UNITED STATES PATENT AND TRADEMARK OFFICE

APPLICATION NO.	FILING DATE	FIRST NAMED INVENTOR	ATTORNEY DOCKET NO.	CONFIRMATION NO.
10/699,335	10/31/2003	Anthony J. Cafferata	J-3763	5399
28165	7590	01/30/2007		
S.C. JOHNSON & SON, INC. 1525 HOWE STREET RACINE, WI 53403-2236			EXAMINER FIDEI, DAVID	
			ART UNIT 3728	PAPER NUMBER

Office Action Summary

DETAILED ACTION

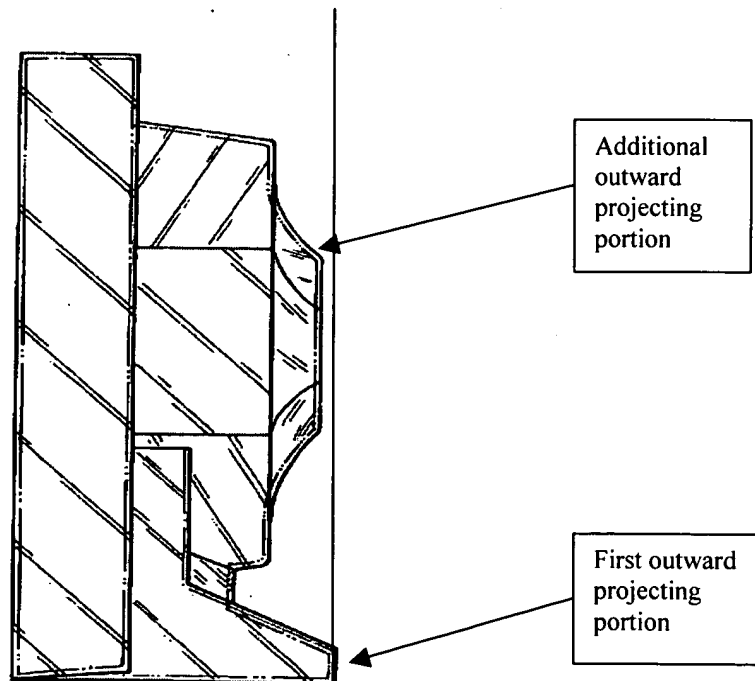
5. Claims 1-4, 7, 8 and 11-14 rejected under 35 U.S.C. 102(b) as anticipated by or, in the alternative, under 35 U.S.C. 103(a) as obvious over Perkins (US Patent no. 4,781,289). As to claims 1, 2, 13 and 14 Perkins discloses a package for containing and displaying at least one article comprising a back panel 12 and a front panel attached to said back panel defining a blister 18. A first outward projecting portion in a bottom portion of the blister is defined by support structure 22 and at least one additional outward projecting portion having a depth and shape conforming to at least a portion of the at least one article is defined by enclosure 20. Col. 3, lines 8-10 states the depth of support structure 22 should be comparable to the depth of product enclosure 20. To the extent that this is not viewed as setting forth a projecting portion 20 equal in depth to a greatest depth in the first outward projecting portion, such a difference would have involved a mere change in the size of a component. A change in size is generally recognized as being within the level of ordinary skill in the art. In re Rose, 105 USPQ 237 (CCPA 1955). Also, it has been held that where the only difference between the prior art device and the claimed device was a recitation of relative dimensions, the claimed device was not patentably distinct from the prior art device, Gardner v. TED Systems, Inc., 725 F.2d 1338, 220 USPQ 777 (Fed. Cir. 1984), cert. Denied, 469 U.S. 830, 2325 USPQ 232 (1984), see M.P.E.P. 2144.04 (IV).

As to claims 3 and 4, the additional outward projecting portion is continuous with the first outward projecting portion in that the blister pack 18 is formed as a unitary member.

As to claims 7 and 8, the first outwardly projecting portion 22 has a front wall of uniform depth relative to surface 15.

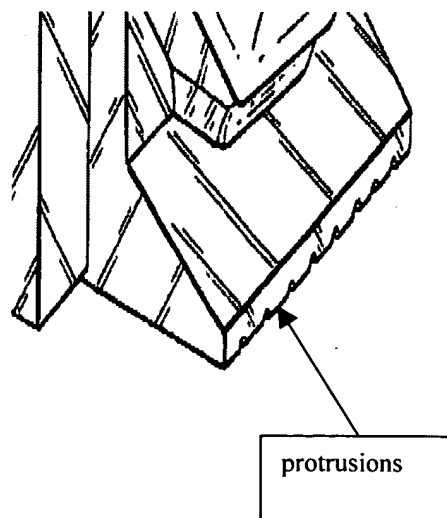
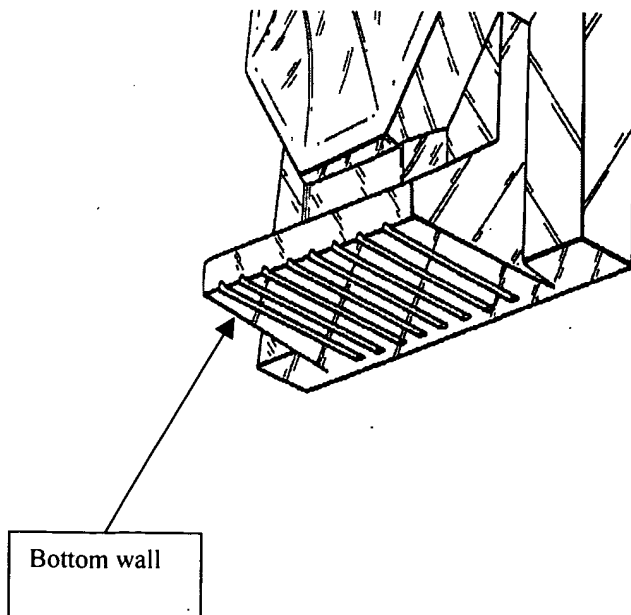
6. Claims 1-12 are rejected under 35 U.S.C. 103(a) as being unpatentable over Humphrey (Patent no. D447,408) in view of Perkins (US Patent no. 4,781,289). Humphrey (Patent no. D447,408). As to claims 1 and 2 a package for containing and displaying at is disclosed comprising a back panel, and a front panel attached to said back panel, wherein said front panel

comprises a blister pack formed of plastic and including a first outward projecting portion in a bottom portion of said blister pack and at least one additional outward projecting portion having a depth and shape conforming to at least a portion of said at least one article, wherein at least a portion said first outward projecting portion extends widthwise at least a substantial portion between a first side of said blister pack and a second side of said blister pack, and has a depth outward sufficient to allow said package to stand substantially upright. As shown by the figure below the depth of said at least a portion of said first outward projecting portion is greater than an outermost projecting portion of the depth of said at least one additional outward projecting portion.

The difference between claims 1, 2 and Humphrey resides in the depth of the first portion equal to a greatest depth of an outermost projecting portion of the additional outward portion.

Perkins Col. 3, lines 8-10 states the depth of support structure 22 should be comparable to the depth of product enclosure 20. It would have been obvious to one of ordinary skill in the art to modify Humphrey by constructing the first portion equal to a greatest depth of an outermost projecting portion of the additional outward portion as suggested by Perkins, in to provide a self supporting package while not making the base excessively deep.

As to claim 3, a package is shown above according to claim 1 wherein said at least one additional outward projecting portion is continuous with said first outward projecting portion.

As to claim 4, a blister pack according to claim 2 is shown wherein said at least one additional outward projecting portion is continuous with said first outward projecting portion.

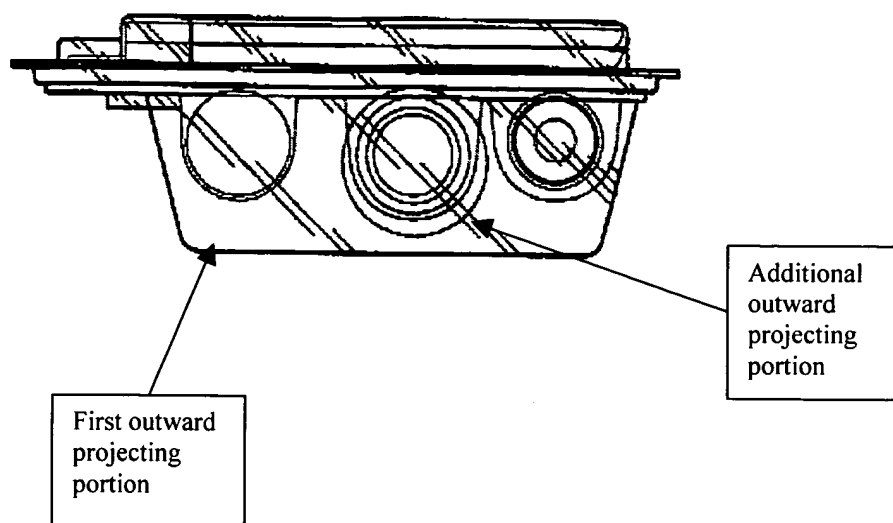
As to claim 5, a package according to claim 1 wherein said first outward projecting portion includes a bottom wall having integral therein at least two spaced apart downward protrusions, see the figure below

As to claim 6, a blister pack is shown according to claim 2 wherein said first outward projecting portion includes a bottom wall having integral therein at least two spaced apart downward protrusions. As shown above there are a plurality of protrusions in as much as is claimed.

As to claims 7 and 8, a package according to claims 1 and 2 is shown where the first outward projecting portion includes a front wall of uniform depth.

As to claims 9 and 10, one of said portions of non-uniform depth is a wall of one of said at least one additional outward projecting portion

As to claims 11 and 12, the first portion is substantially rectangular when view from the front side in as much as is claimed.

FIG. 1

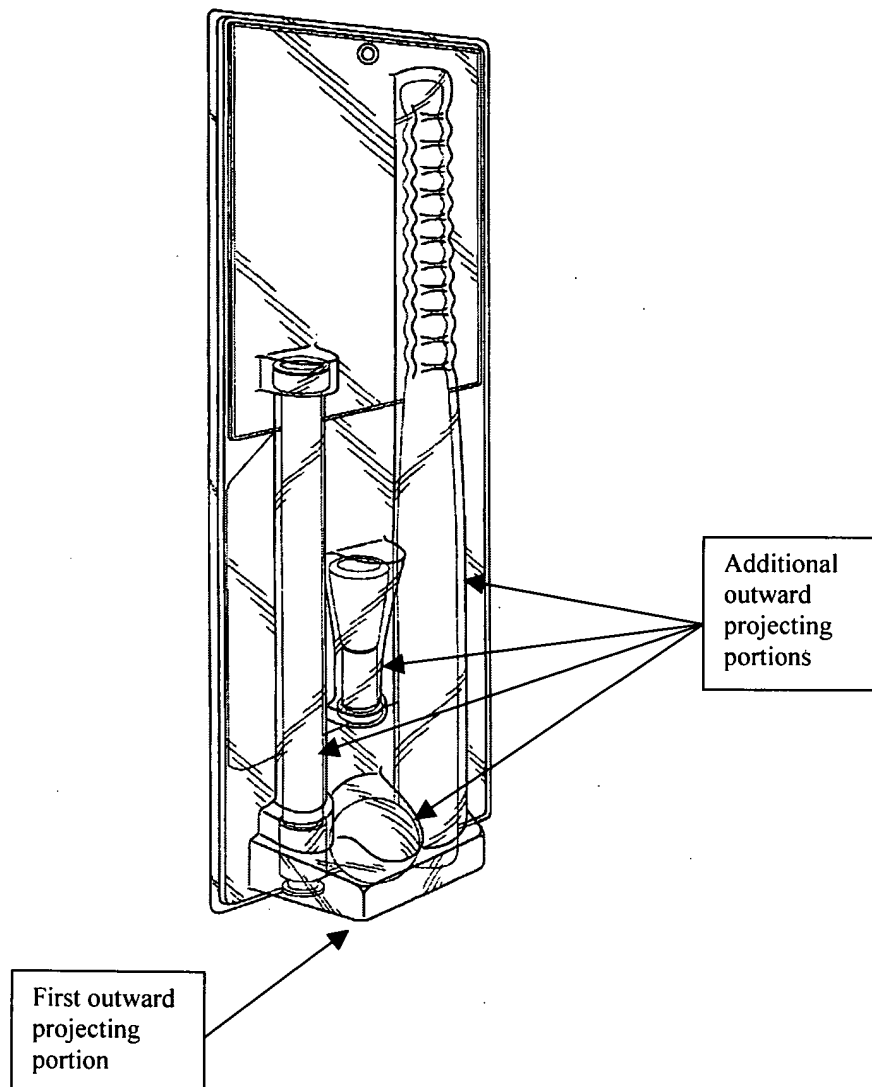
7. Claims 1-4, 7-12, 15 and 16 are rejected under 35 U.S.C. 103(a) as being unpatentable over Udwin et al (Patent no. D467,494) in view of Perkins (US Patent no. 4,781,289) Udwin et al (Patent no. D467,494). As to claims 1 and 2 a package for containing and displaying at is disclosed comprising a back panel, and a front panel attached to said back panel, wherein said front panel comprises a blister pack formed of plastic and including a first outward projecting portion in a bottom portion of said blister pack and at least one additional outward projecting portion having a depth and shape conforming to at least a portion of said at least one article, wherein at least a portion said first outward projecting portion extends widthwise at least a substantial portion between a first side of said blister pack and a second side of said blister pack, and has a depth outward sufficient to allow said package to stand substantially upright. As shown by the figure below the depth of said at least a portion of said first outward projecting portion is greater than an outermost projecting portion of the depth of said at least one additional outward projecting portion.

The difference between claims 1, 2 and Udwin resides in the depth of the first portion equal to a greatest depth of an outermost projecting portion of the additional outward portion. Perkins Col. 3, lines 8-10 states the depth of support structure 22 should be comparable to the depth of product enclosure 20. It would have been obvious to one of ordinary skill in the art to modify Humphrey by constructing the first portion equal to a greatest depth of an outermost projecting portion of the additional outward portion as suggested by Perkins, in to provide a self supporting package while not making the base excessively deep.

As to claims 3 and 4, a package is shown above according to claims 1 and 2 wherein said at least one additional outward projecting portion is continuous with said first outward projecting portion.

As to claims 7 and 8, a package according to claims 1 and 2 is shown where the first outward projecting portion includes a front wall of uniform depth.

As to claims 9 and 10, one of said portions of non-uniform depth is a wall of one of said at least one additional outward projecting portion

As to claims 11 and 12, the first portion is substantially rectangular when view from the figure on the previous page in as much as is claimed.

As to claim 15 and 16, a package is shown in the figure where said at least one additional outward projecting portions are present, on either side of the middle additional projection portion, wherein said two of said at least two additional outward projecting portions are of different depths from each other.
